UNITED STATES
NUCLEAR REGULATORY COMMISSION
OFFICE OF NUCLEAR REACTOR REGULATION
WASHINGTON, D.C. 20555

December 30, 1988

NRC BULLETIN NO. 88-07, SUPPLEMENT 1: POWER OSCILLATIONS IN BOILING WATER REACTORS (BWRs)

**FIGURE 1
DEFINED OPERATING REGIONS**

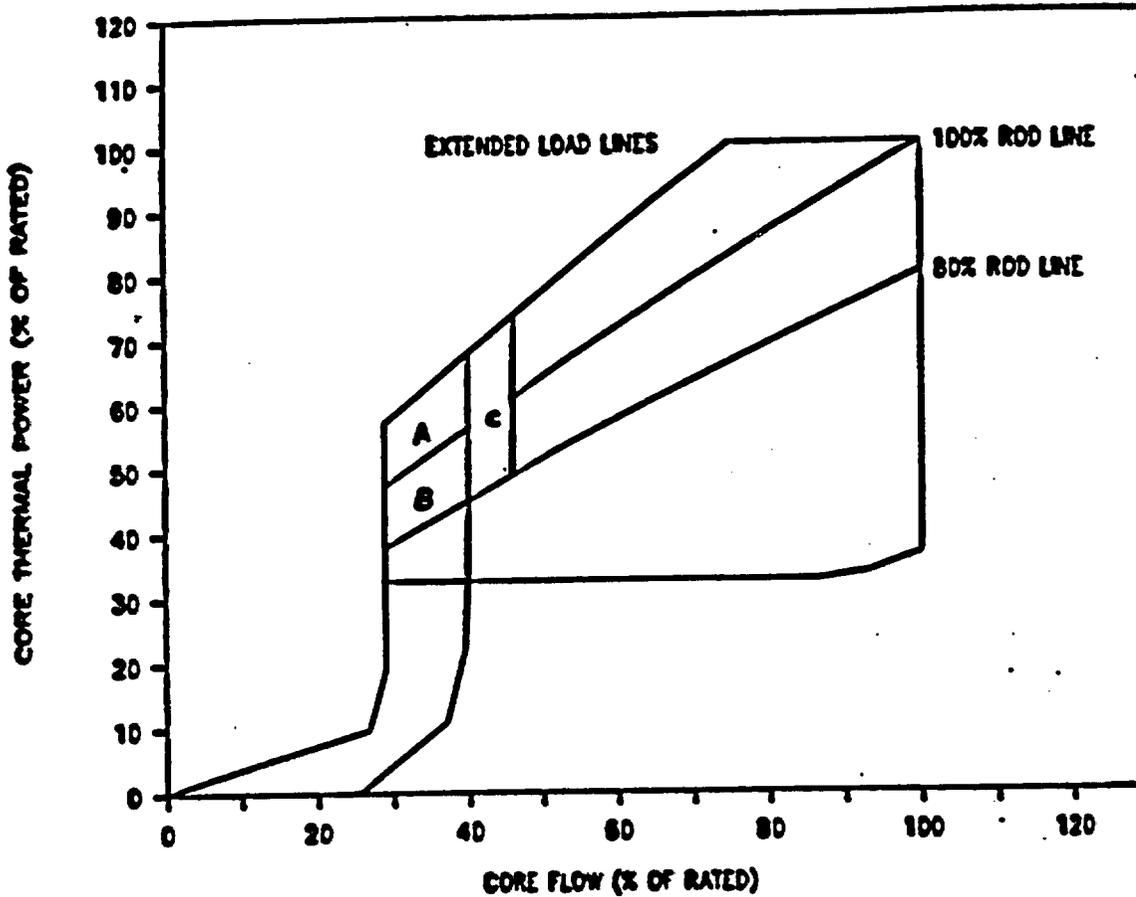
- (2) The boundaries of Regions A, B, and C shown in Figure 1 of the GE recommendations (Attachment 1) were derived for those BWRs using NRC approved GE fuel. For BWRs using fuel supplied by other vendors, these regions should be adopted in principle, but the power/flow boundaries should be based on existing boundaries that have been previously approved by the NRC. For proposed new fuel designs, the stability boundaries should be reevaluated and justified based on any applicable operating experience,

- (3) The BWROG recommendations of Attachment 1 are ambiguous with respect to permissible conditions for entry of Regions B and C. Although the recommendations state that intentional operation in Region B is not permitted and operation in Region C is permitted only for purposes of fuel conditioning during rod withdrawal startup operations, intentional entry into Region B or C is also allowable in situations where rod insertion or a flow increase is required by procedures to exit Regions A and B after unintentional entry. Licensees should ensure that the procedures and training employed for implementation of these recommendations avoid any similar ambiguity which could lead to operator confusion.

1. Intentional operation shall not be allowed in Region A or Region B of Figure 1.

4. Intentional operation in Region C shall be allowed only for control rod withdrawals during startup requiring PCIOMR. This region should be avoided for control rod sequence exchanges, surveillance testing and reactor shutdowns.

calculated changes in core decay ratio using NRC approved methodology, and/or core decay ratio measurements. There should be a high degree of assurance that instabilities will not occur under any circumstances of operation in Region C.
